**DESIGN ANALYSIS REPORT
ASARCO EAST HELENA
CORRECTIVE ACTION MANAGEMENT UNIT (CAMU)
PHASE 2 CELL**

IX. Responses to May 28, 2007 Initial Comments On Design Analysis Report Asarco East Helena Plant Corrective Action Management Unit (CAMU) Phase 2 Cell Revised May 2007

X. Responses to June 2, 2007, Additional Comments on the Revised Design Analysis Report for the ASARCO East Helena Smelter CAMU Cell 2

FIGURE
3-6

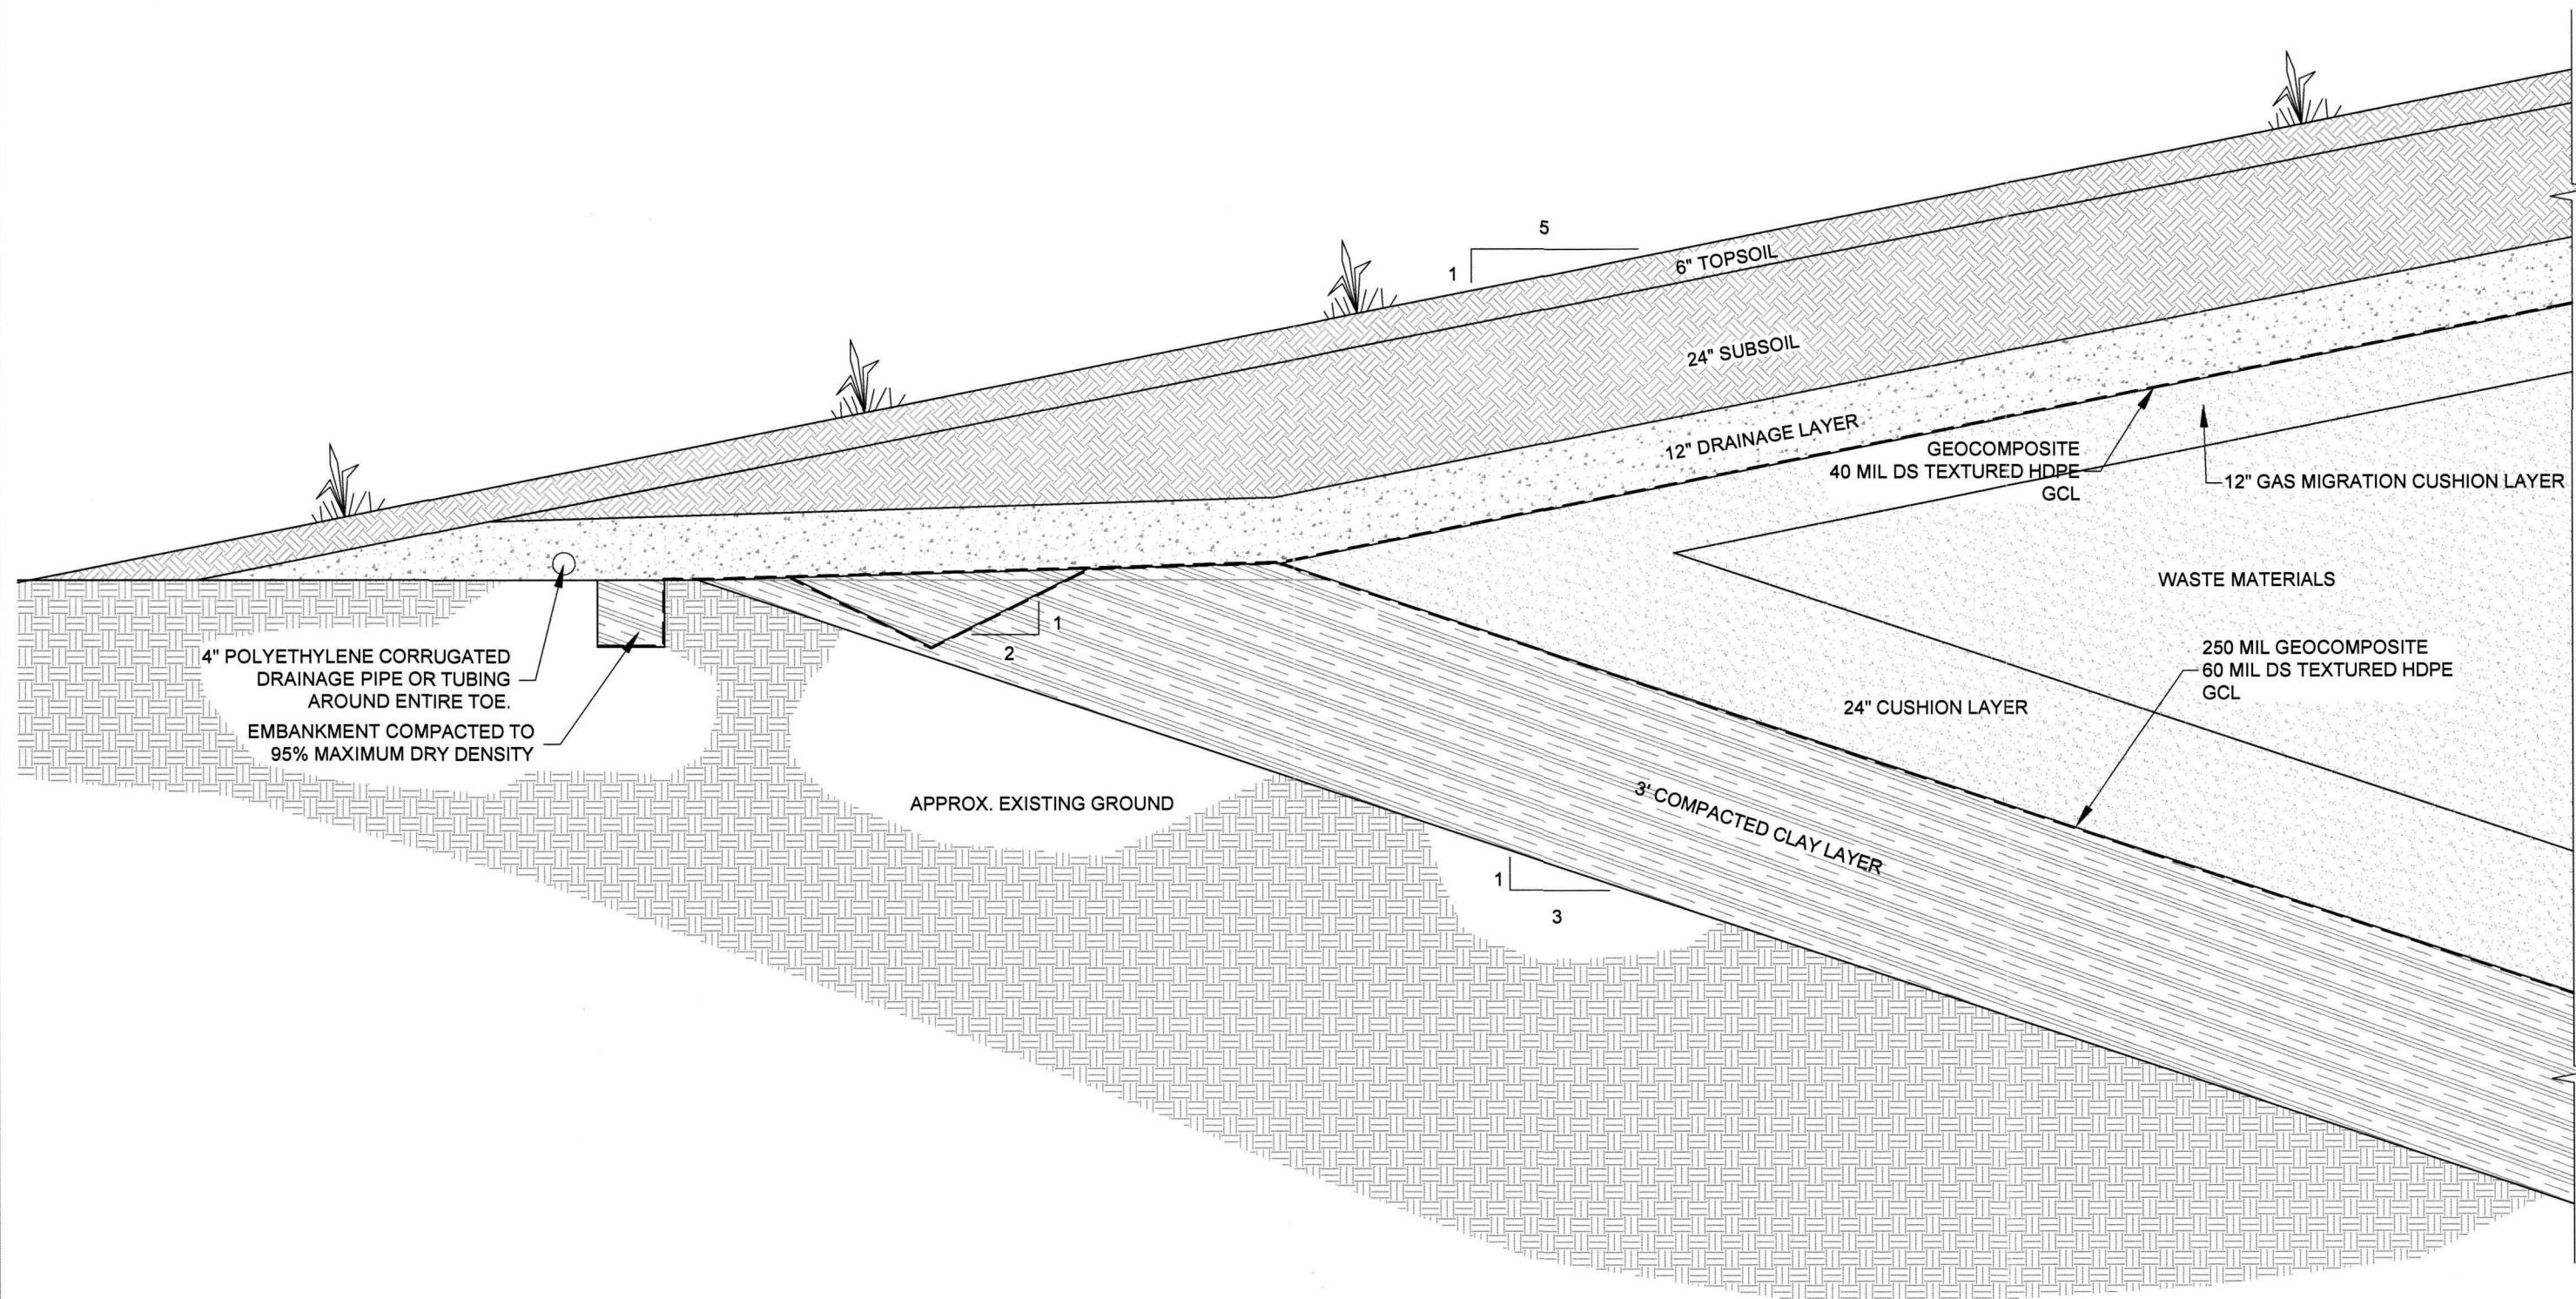
Comment 17. Section 3.6 and Section 3.7: The gas migration layer and cushion layer on top of the waste is inconsistent between Figure 3.5 and Figure 3-6. This should be corrected.

Comment 20. Section 3.7.1.3 Cap Composite Liner: This section states the cap liner will consist of a 40-mil double-sided textured HDPE FML on top of a geosynthetic clay liner (GCL). However, various figures and specification sheets do not match the text and appear to have the GCL on top of the FML. The following figures and sheets must be modified: Figure 3-6; Sheet Number 28; and Sheet Number 30.

Response: Figure 3-6 has been revised to show the cushion layer as the 12", as required by Comment 3 on page xliii and not 24". This change is shown on replacement Figure 3-6.

Response: Figure 3-6 and Sheets 28 and 30 have been revised to clearly show the 40-mil double-sided textured HDPE FML on top of the GCL.

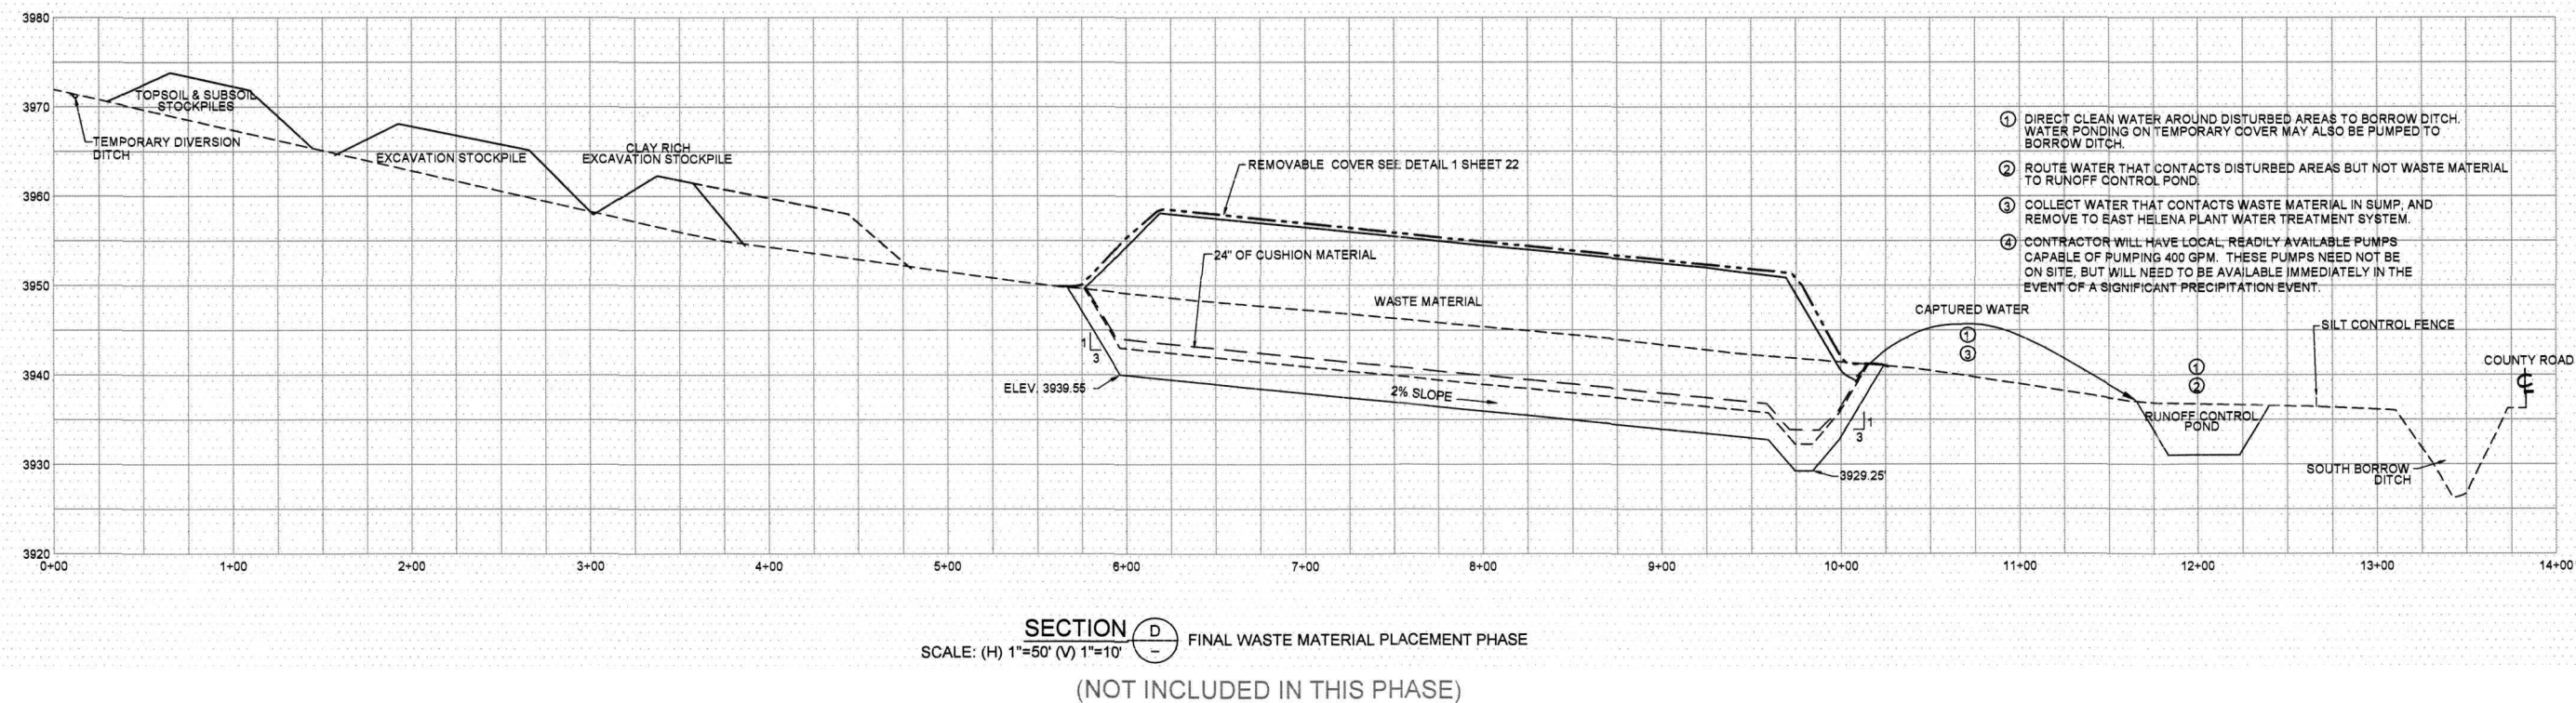
Comment 26. Appendix I Sheet 26 and Sheet 27: The cushion material size specifications are inconsistent. Sheet 27 should be corrected to match Sheet 26

Response: Sheet 27 has been corrected to match Sheet 26 as shown on replacement Sheets 27 and 26.

ASARCO LLC - EAST HELENA PLANT
CAMU PHASE 2 CELL PROJECT
CROSS SECTIONS

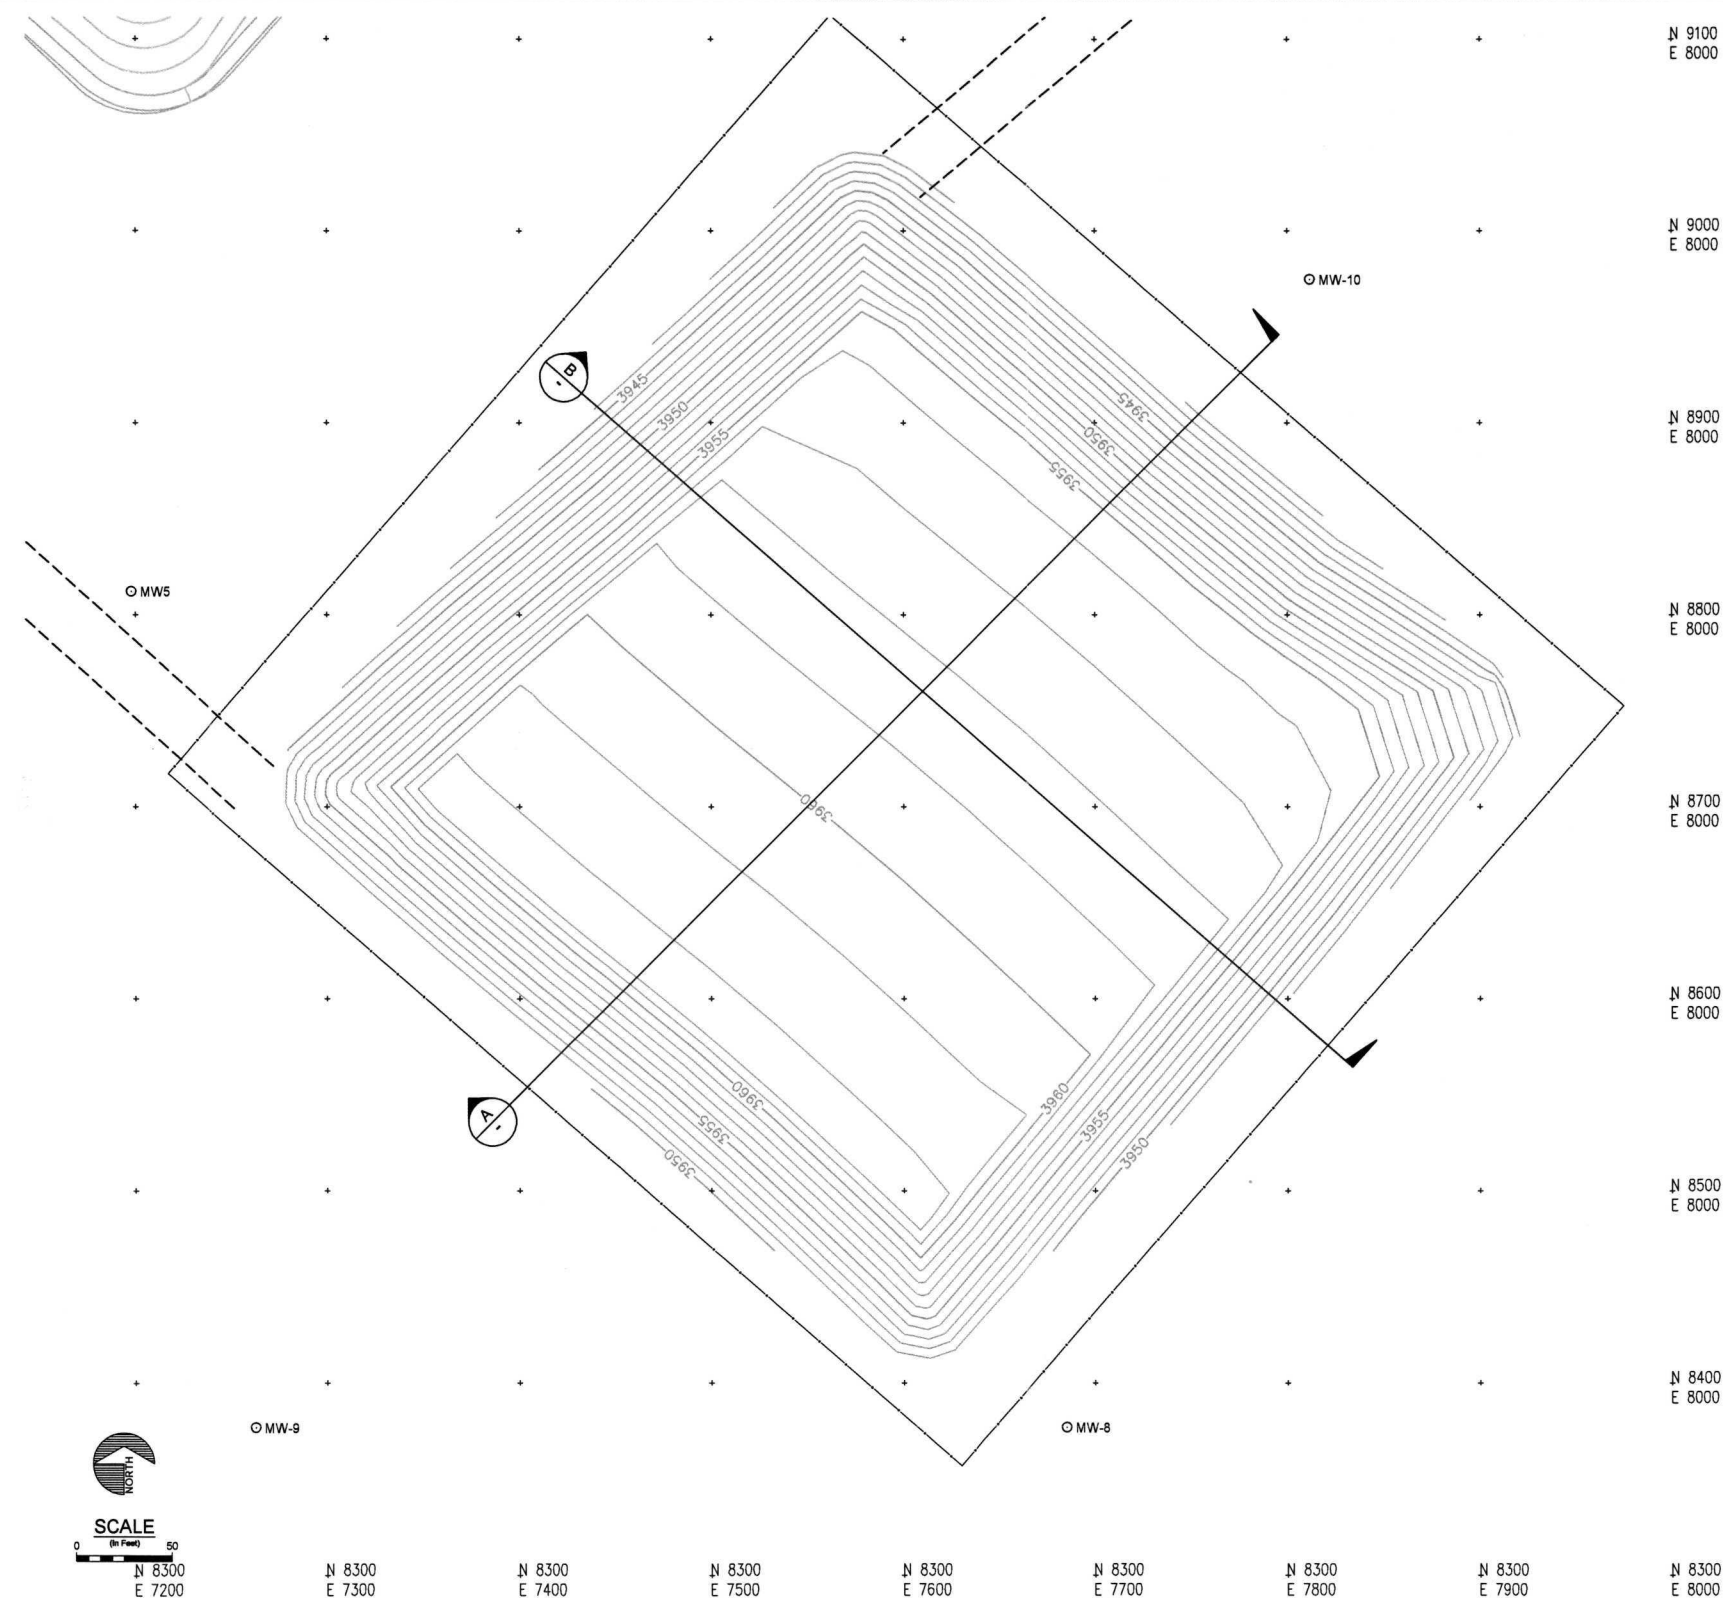
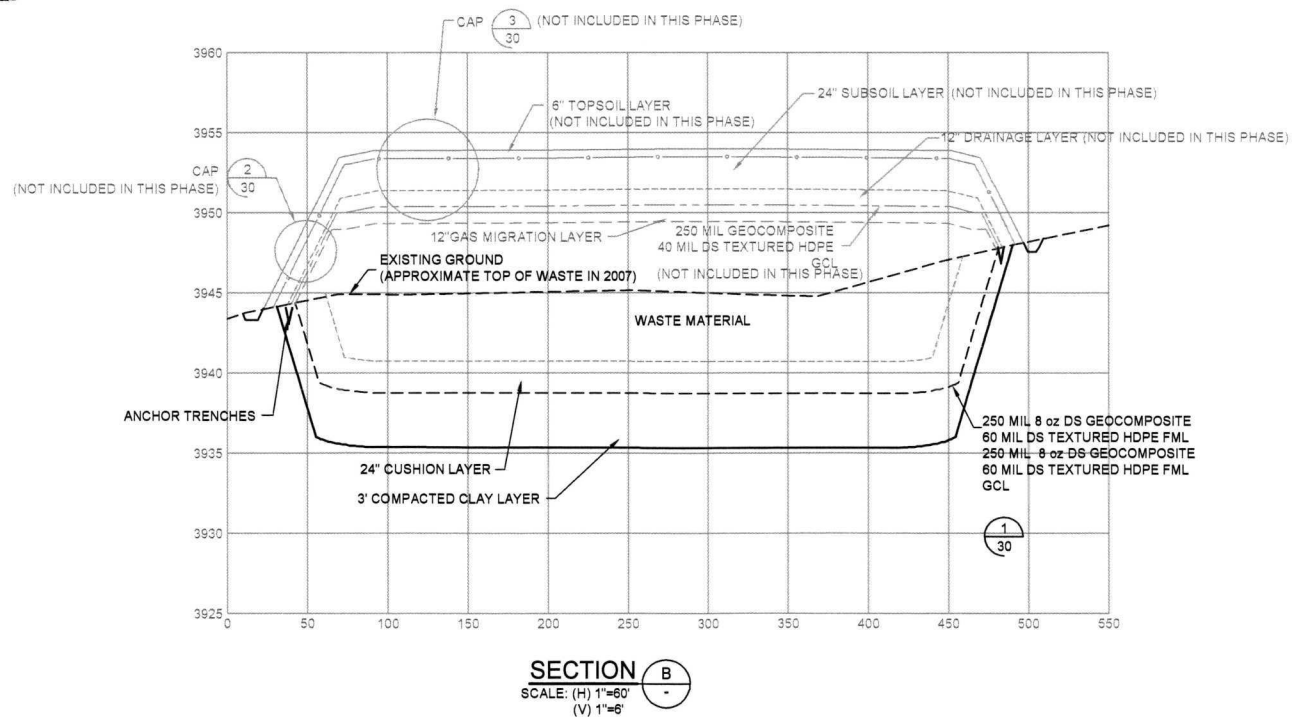
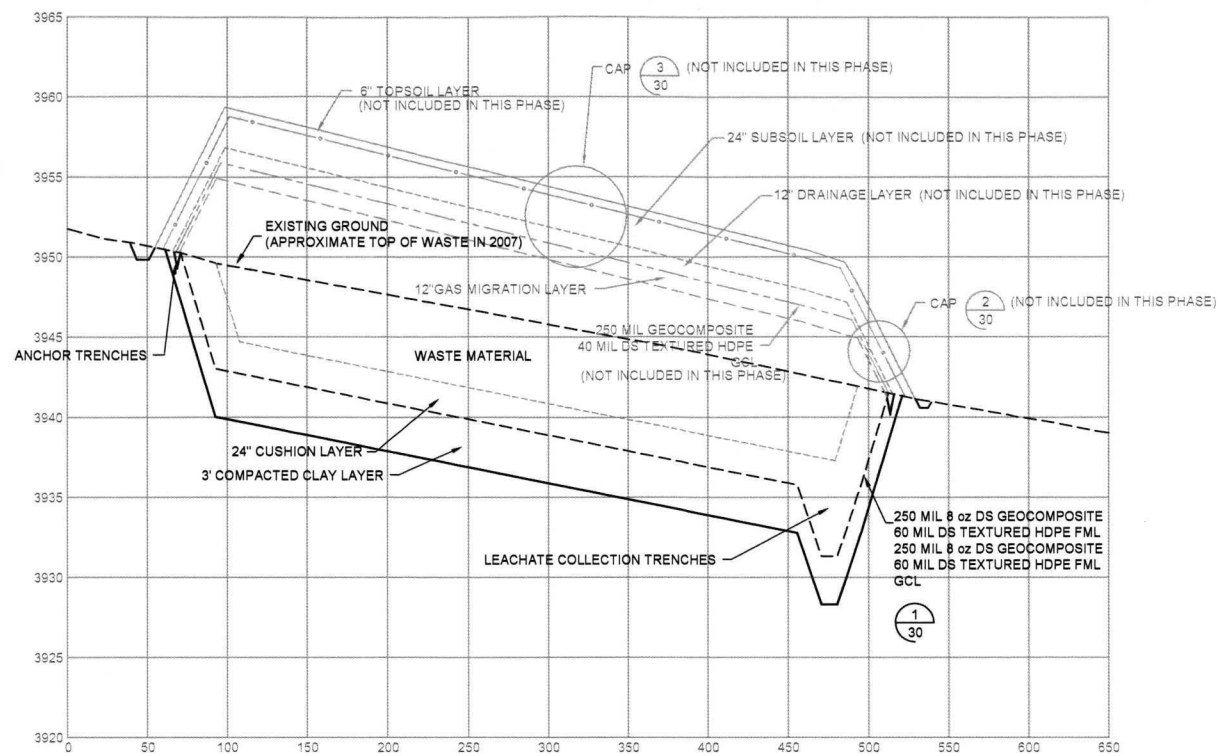
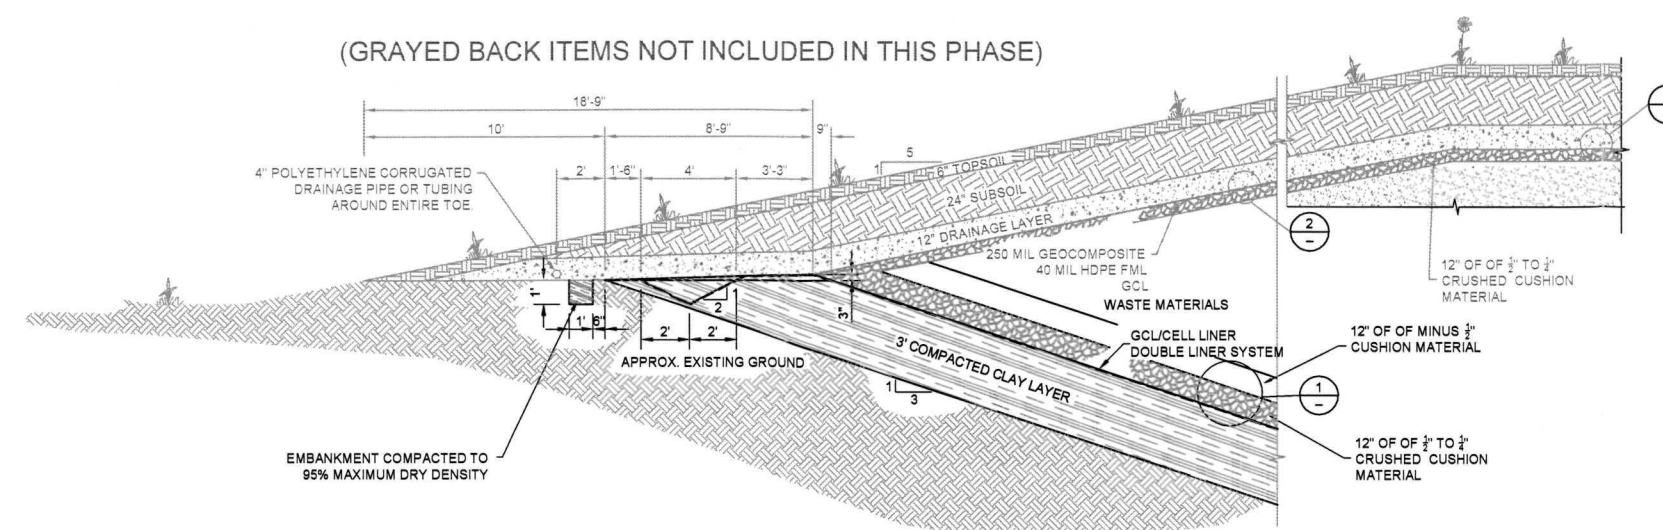
Comment 5. Appendix I, Project Drawings, Sheet 28: The required 24-inch thick cushion layer on top of the bottom liner, while shown on both Sections A and B, is not identified. See Figure 3.5 of the design report for similar sections with proper identification.

Response: Sheet 28 has been revised to identify the 24-inch thick cushion layer as shown on revised Sheet 28.
